# BULLETIN

## *PRODUCT SERVICES - Schaumburg*

Subject: MSR2000 and MSF5000 Ferro Resonant power supplies,  
TPN1185A, TPN1218A, TPN1184A, TPN1192A, TPN1226A, TPN1227A

# Product Services Bulletin

Figure 6. Circuit Board Detail of Crosspoint and Manual Control Board TRN6478AA/AB Showing Modification Details

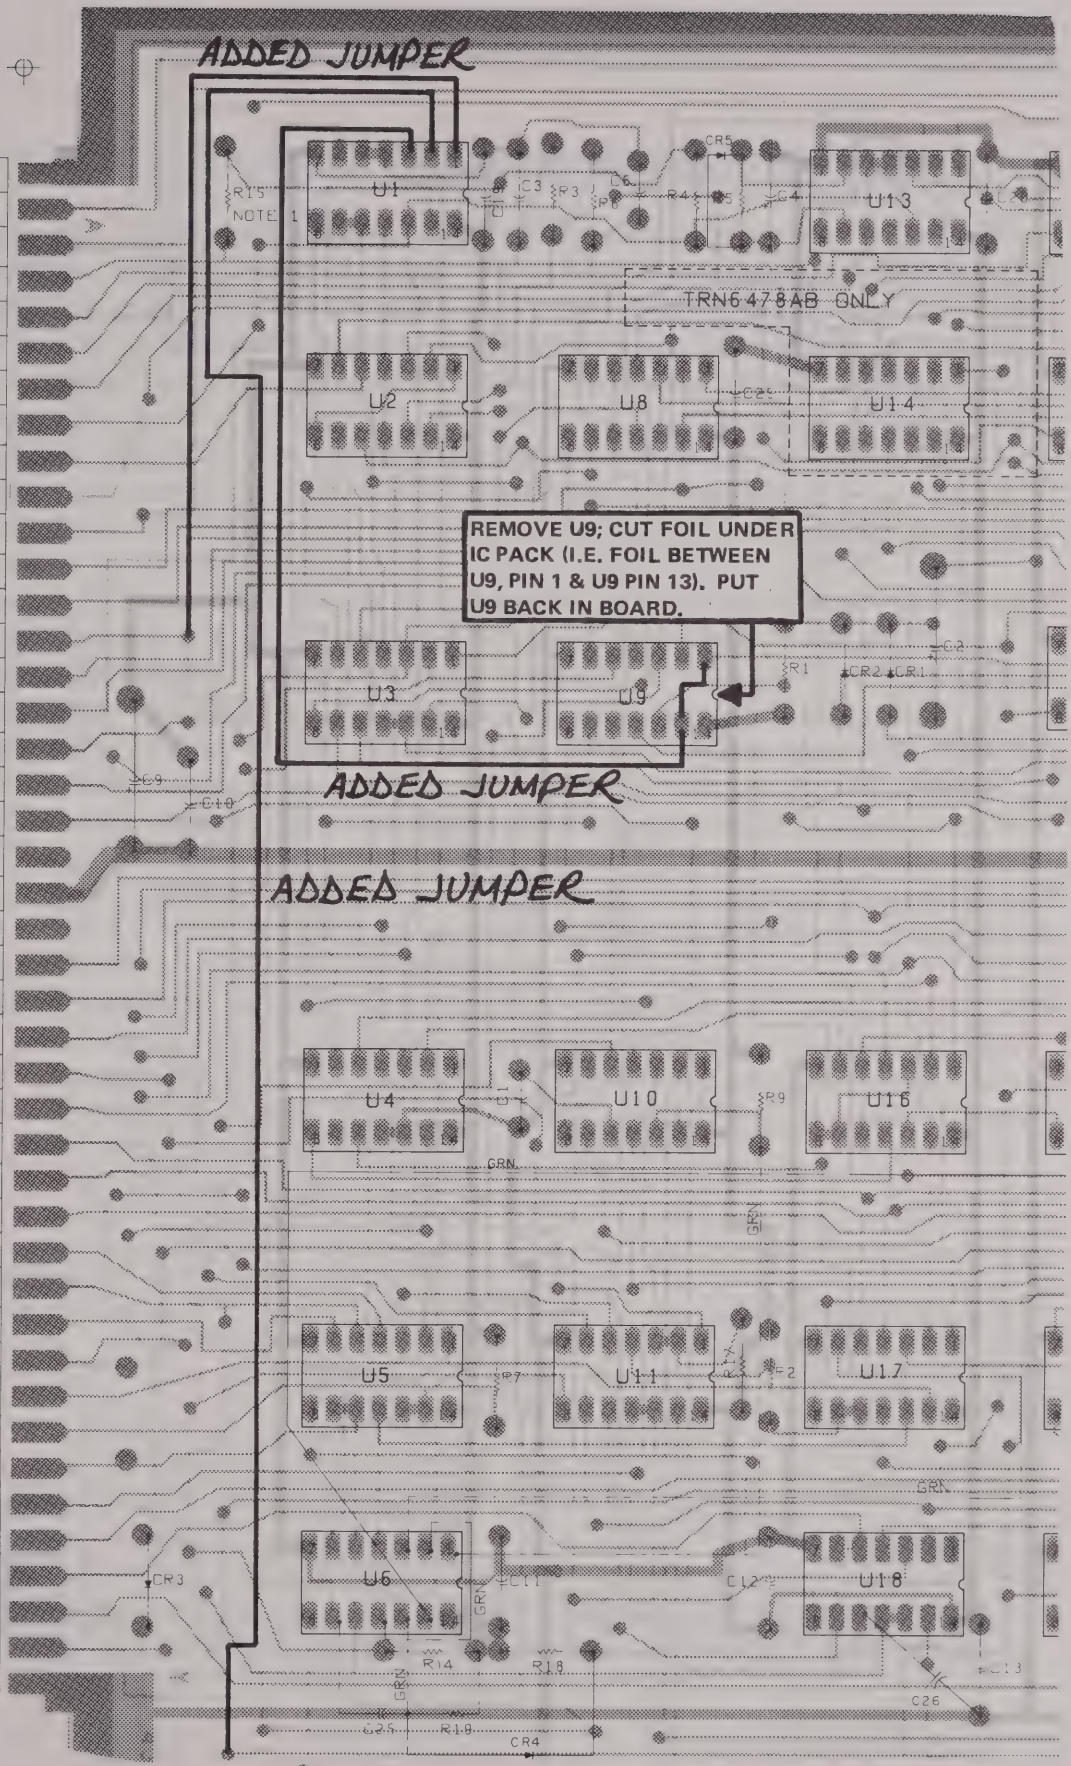
2. With the modification, U21B will be inhibited from setting until D3SEC switches high. See Figures 5 and 6 for the modification details.

Figure 9. Partial Schematic of TRN6470B/B-1 and TRN6470C/C-1 Register Control Boards Showing Modification Details

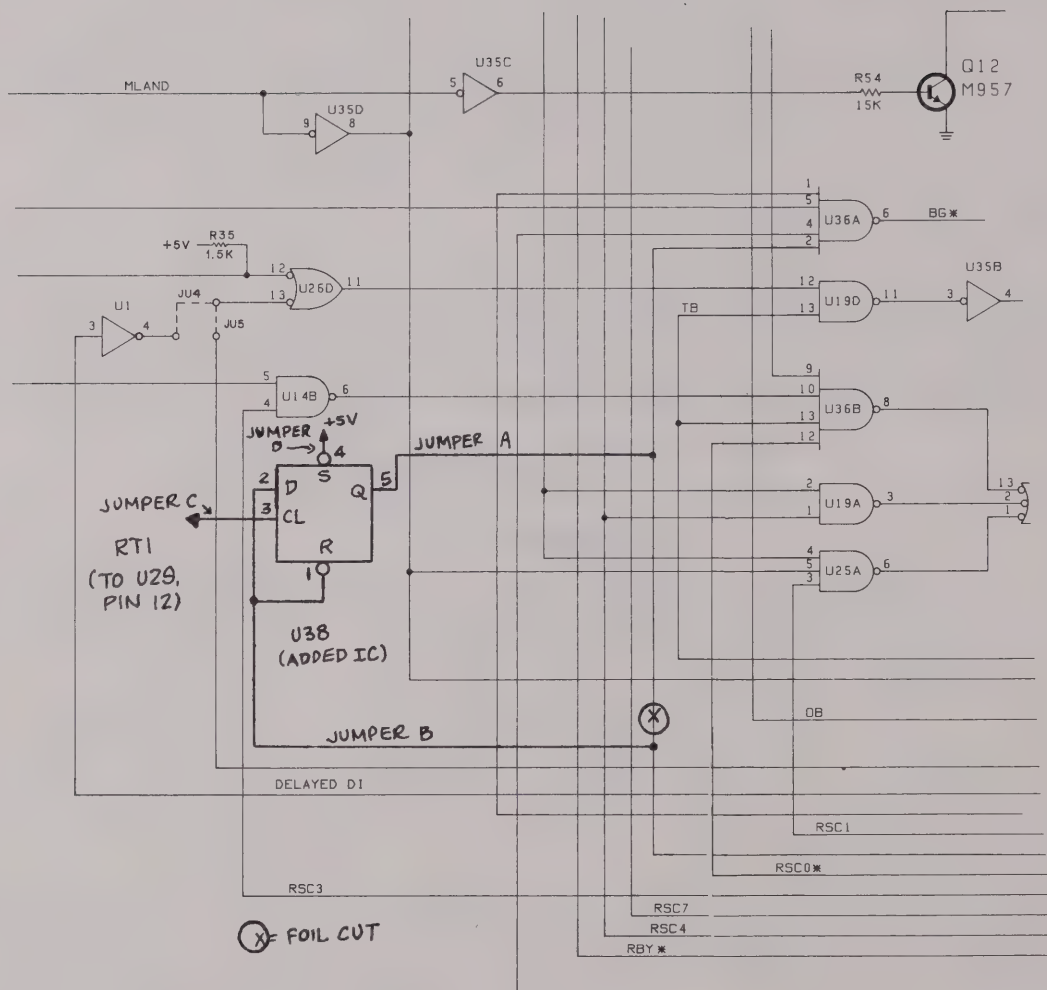
An additional 51-84371K24, type 7474 "D" flip-flop must be added to the board (see Figure 9) to accomplish the modification. This IC will be physically attached to the top of IC27, as described below and as shown in Figure 10, and will be identified as U38.

Figure 10. Component Side of TRN6470B/B-1 and TRN6470C/C-1 Register Control Board Showing Addition of U38

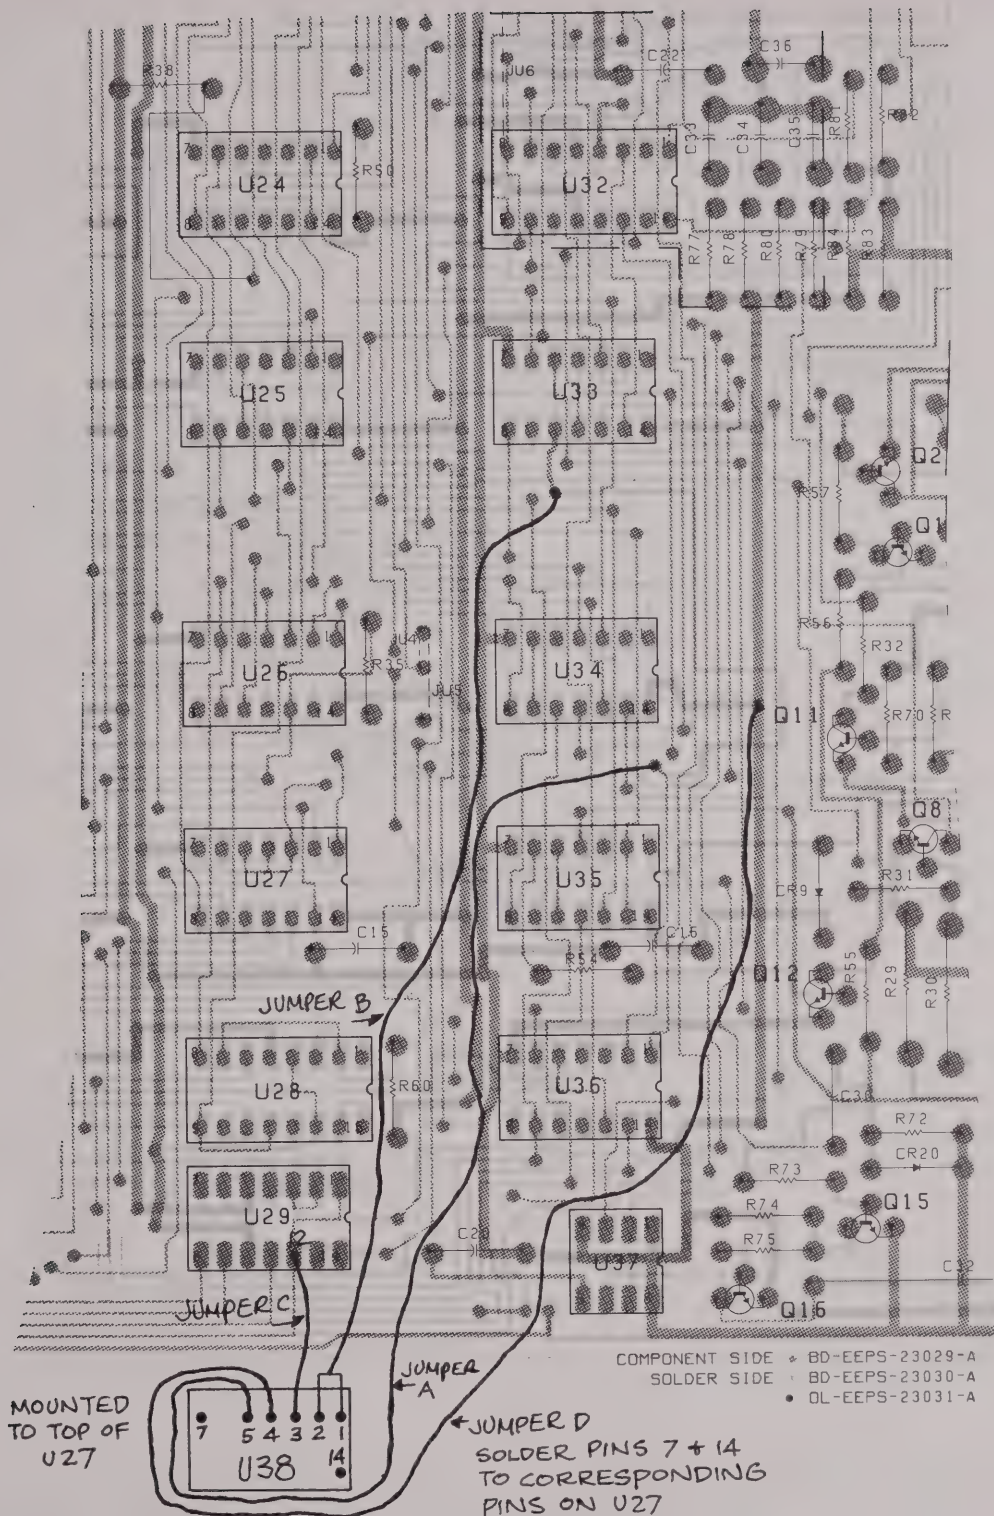
- a) Prepare the extra IC by clipping off pins 6, 8, 9, 10, 11, 12 and 13 close to the body of the IC, being careful not to damage the package.
- b) Carefully bend pins 1, 2, 3, 4, and 5 up and straight out, parallel to the bottom of the IC.
- c) Place IC U38 on top of U27 and solder pin 7 of U38 to pin 7 of U27, and pin 14 of U38 to pin 14 of U27.
- d) Solder together pins 1 and 2 of the top IC, U38.
- e) Solder insulated jumper wires to pins 1/2, 3, 4 and 5 of the top IC, U38, and solder the opposite ends to the component side of the printed circuit board, as shown in Figure 10.

Figure 1

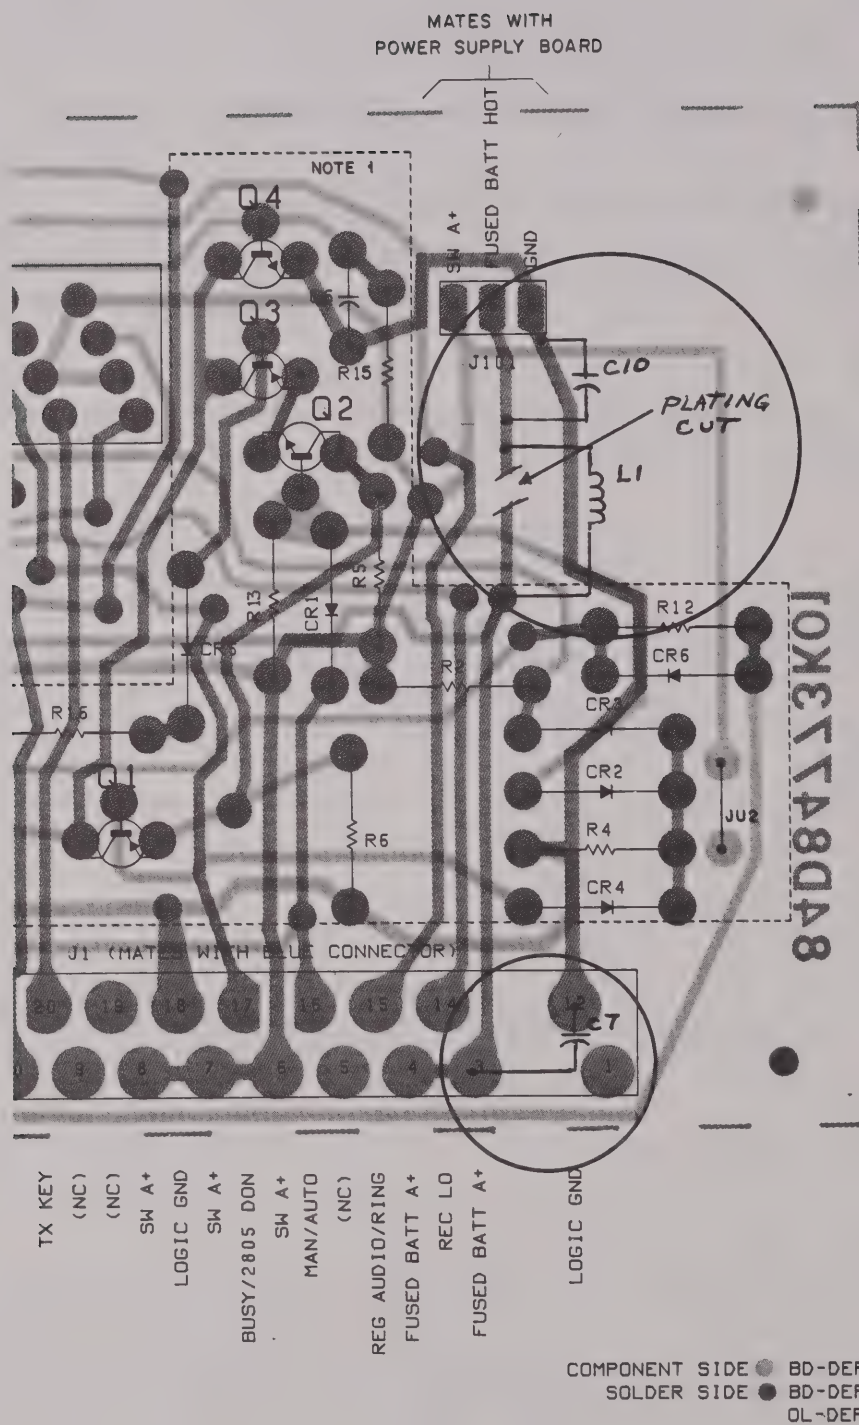
Add an LC filter to the A+ line of the Cable Adapter, as shown in Figure 1.

FIGURE 3

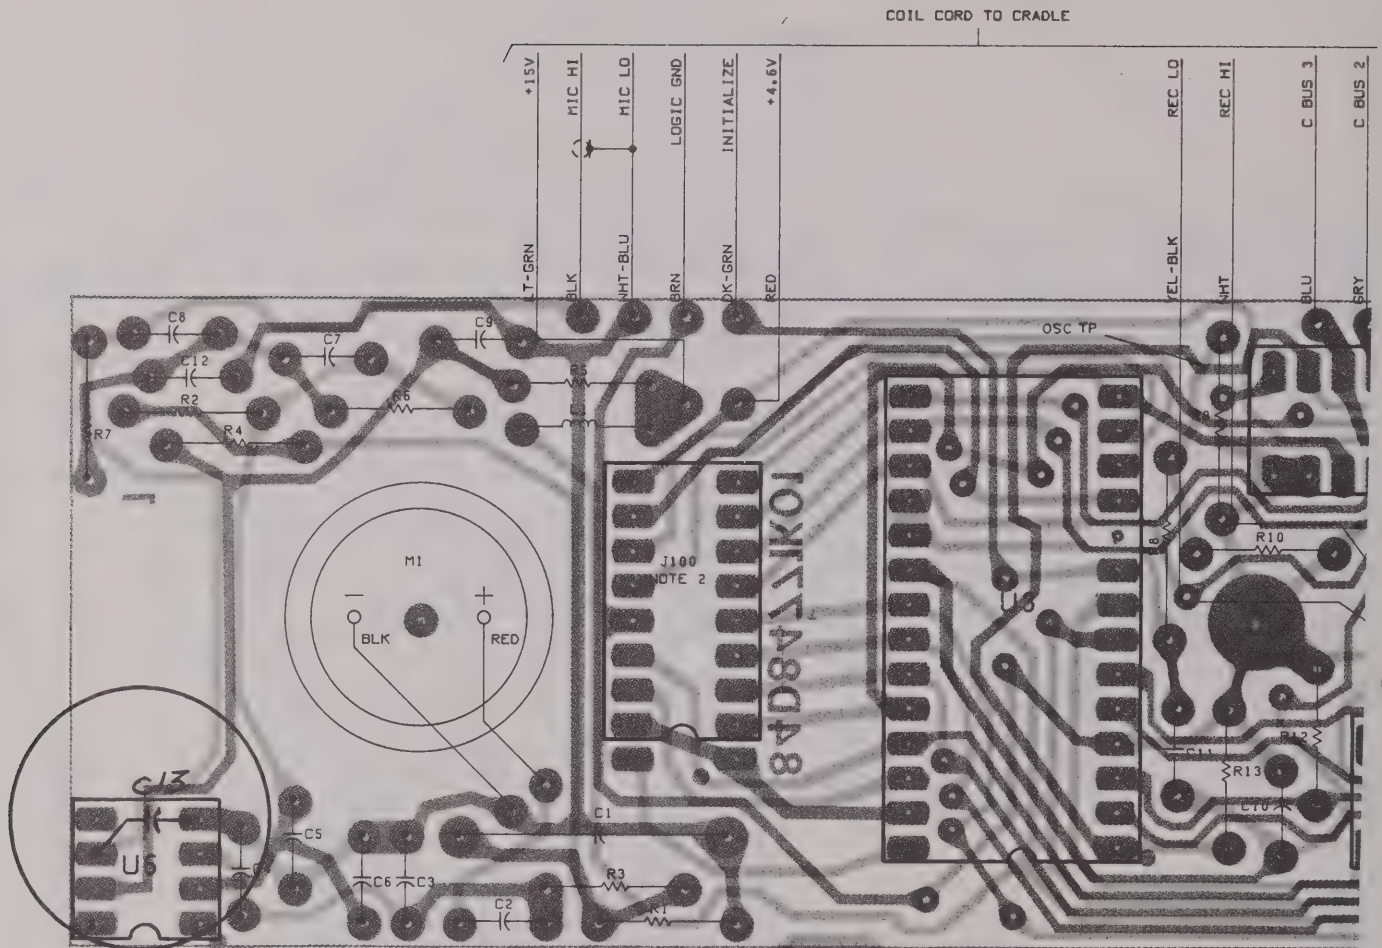
Add a bypass capacitor from the output of the MIC Pre-amp to Audio ground; Pin 6 on Handset Audio Logic Board U6 to Pin 4 of U6 board as shown in Figure 3.

FIGURE 5

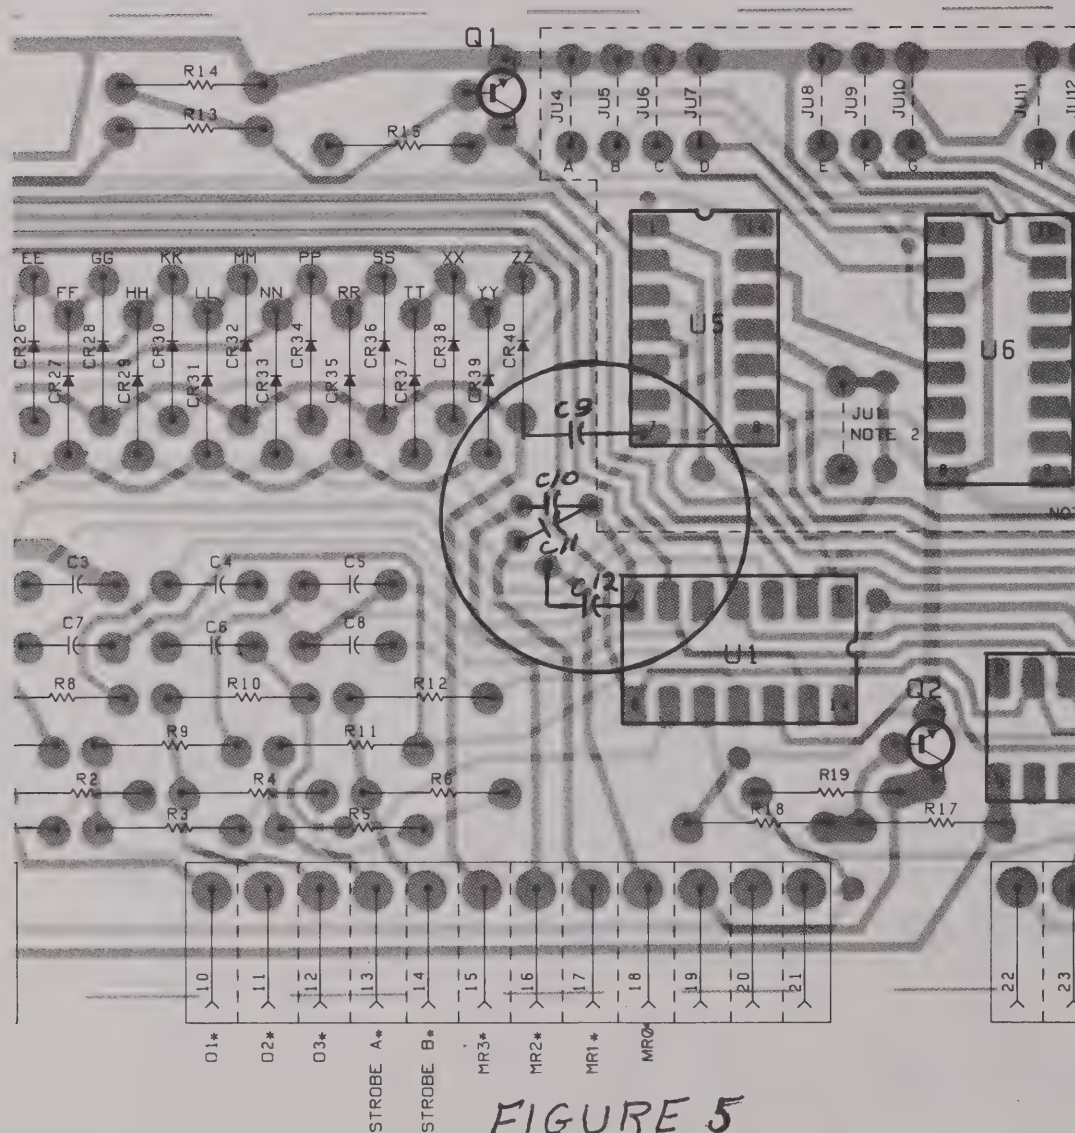
Add (4) bypass capacitors from each of the "MR" lines to ground as shown in Figure 5.

Figure I-1. Cradle Circuit Board Partial Diagram

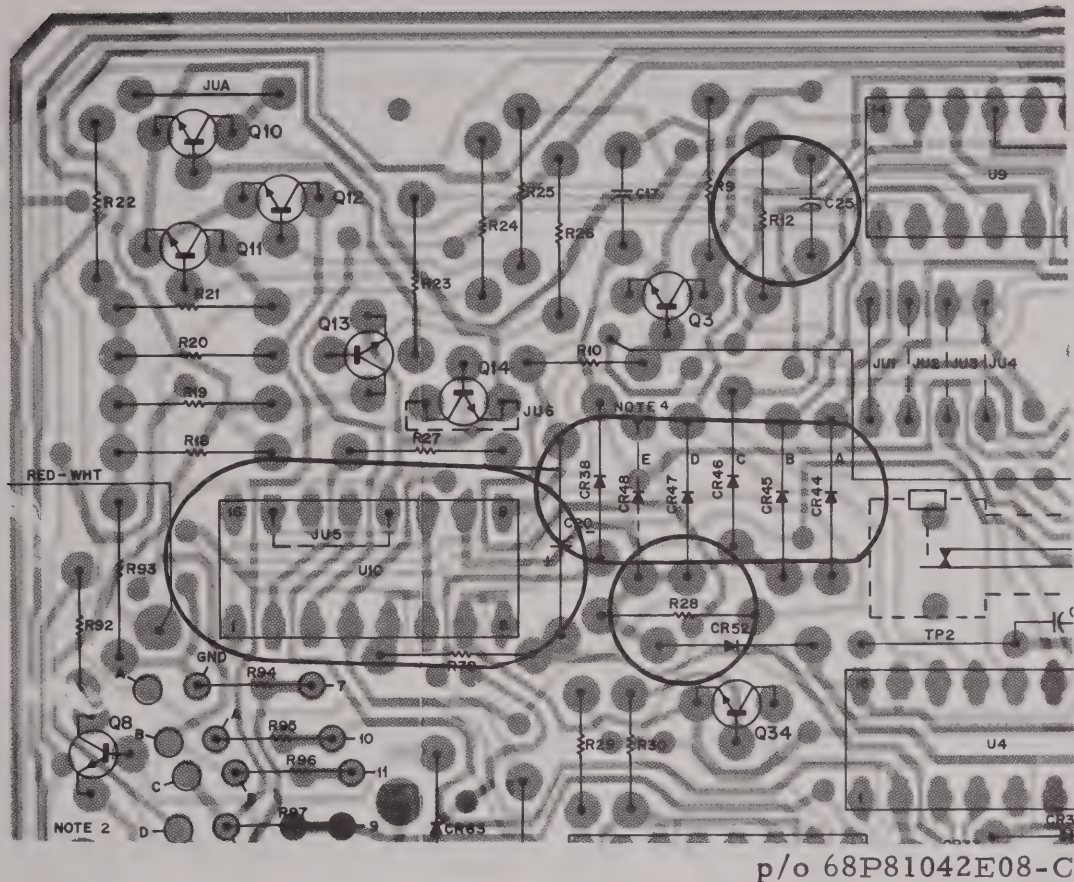
3. In order to reset properly, IC U10, and resistors R12 and R28 must be in (see Figure I-1), and diodes CR44 through CR48 must

Figure II-1. Cradle Circuit Board Partial Diagram

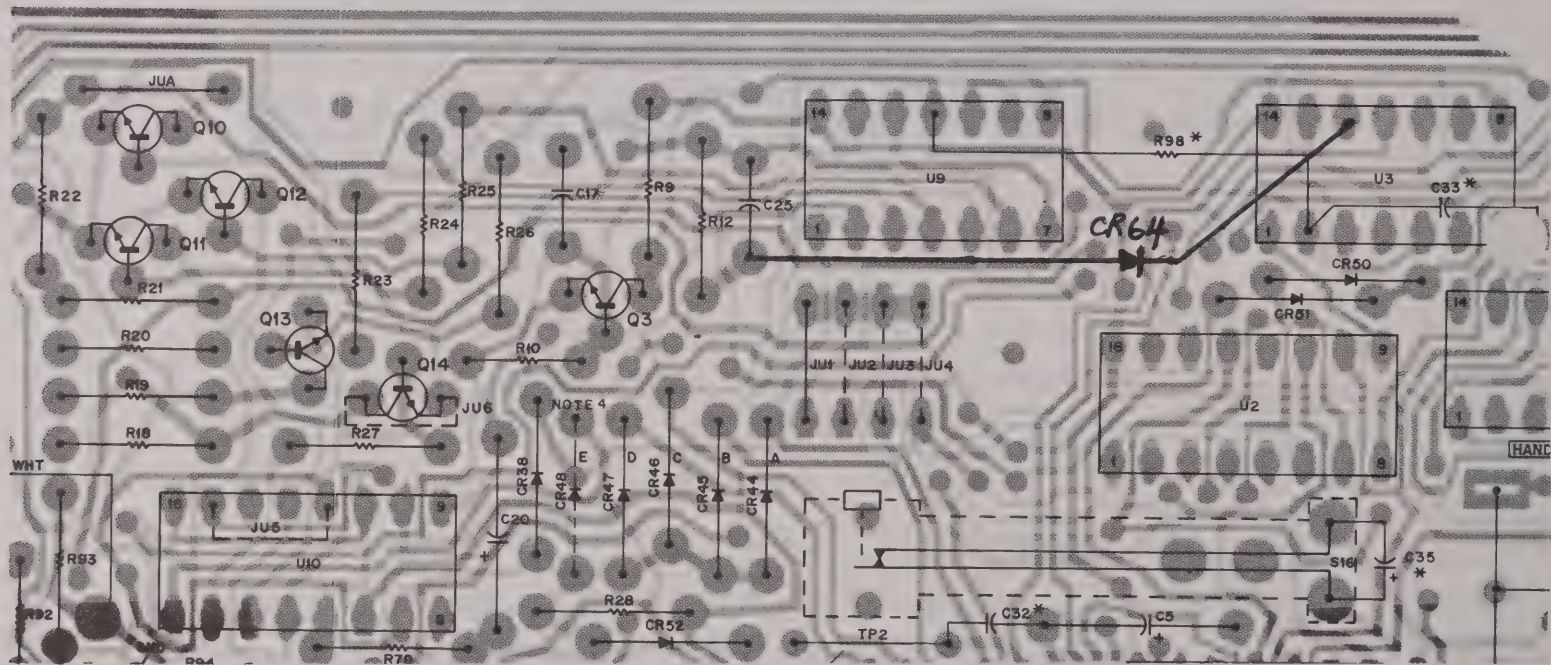
3. To prevent the problem, a silicon diode (part number 48-83654H01) must be added to the cradle board. The diode should be added to the solder side, anode to U10 pin 9, and cathode to U3 pin 12; refer to Figure II-1 for the recommended location. Sleeving should be added to the exposed diode leads.
